PORTLAND LLOYD CENTER DEVELOPMENT

DESIGN
ADVICE
REQUEST #3

12.04.2015
LU NO. 15-167229 DA

DAR # 1 Summary Notes

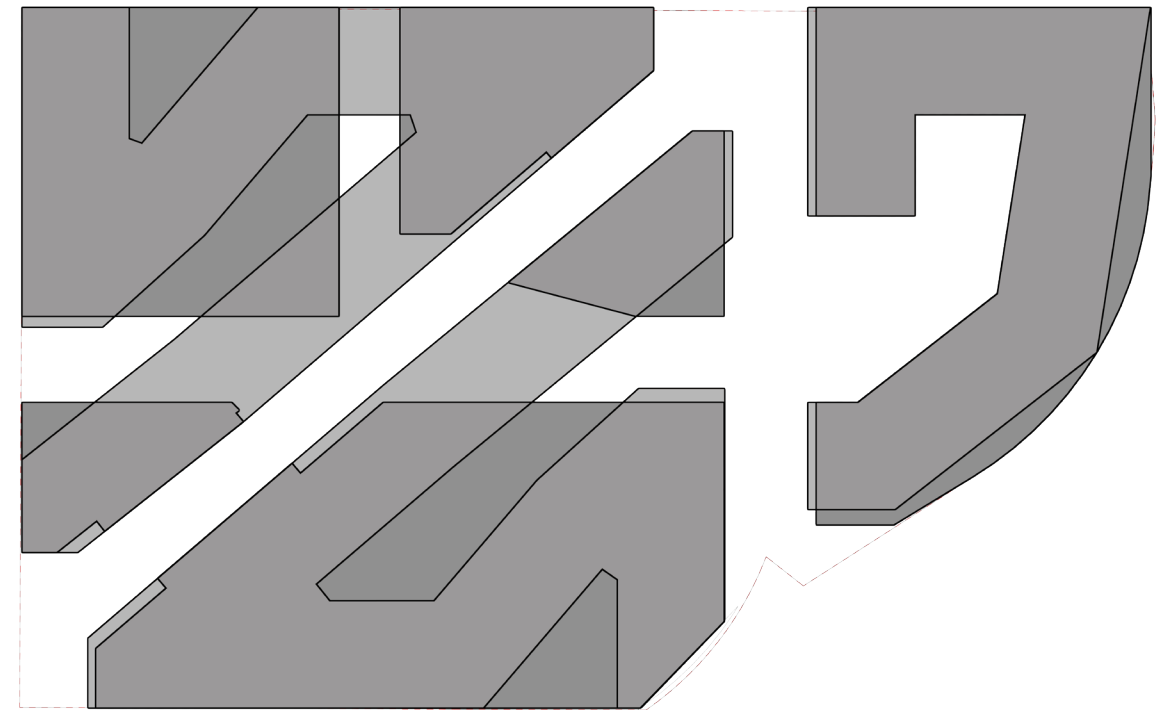
- Diagonal seems constricted
- 500 foot long elevations – unbroken length is an issue
- Buildings go over a perceived “Right-of-way”
- 5-over-1, height variations
- Improved “plaza” - public art (budget)
- Auto/ped circulation could be potential conflict
- East garden - better connection
- 13th avenue is important - permeable
- Less “suburban office campus”
- District parking solution?
- Detail upper private courtyards above the podium

DAR # 2 Summary Notes

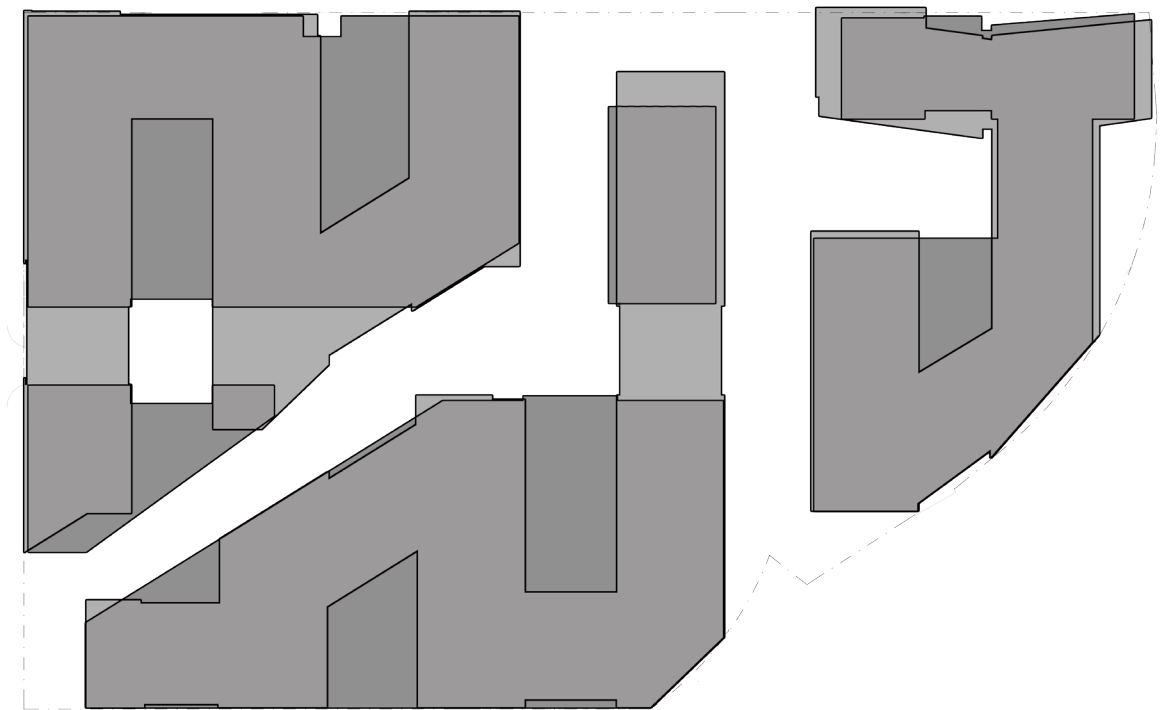
- Unanimous support for the diagonal concept
- Site coverage and uniformity of construction type is still a concern
- Portals / Bridges need more resolution
- Massing needs more articulation while facades need less articulation
- Facades require editing
- Façade design needs to be worthy of such large exposures
- Explore light colored masonry
- Roofs are the 5th elevation given lower heights, so design them.
- Open space should be less forced
- Strive to be timeless rather than fashionable
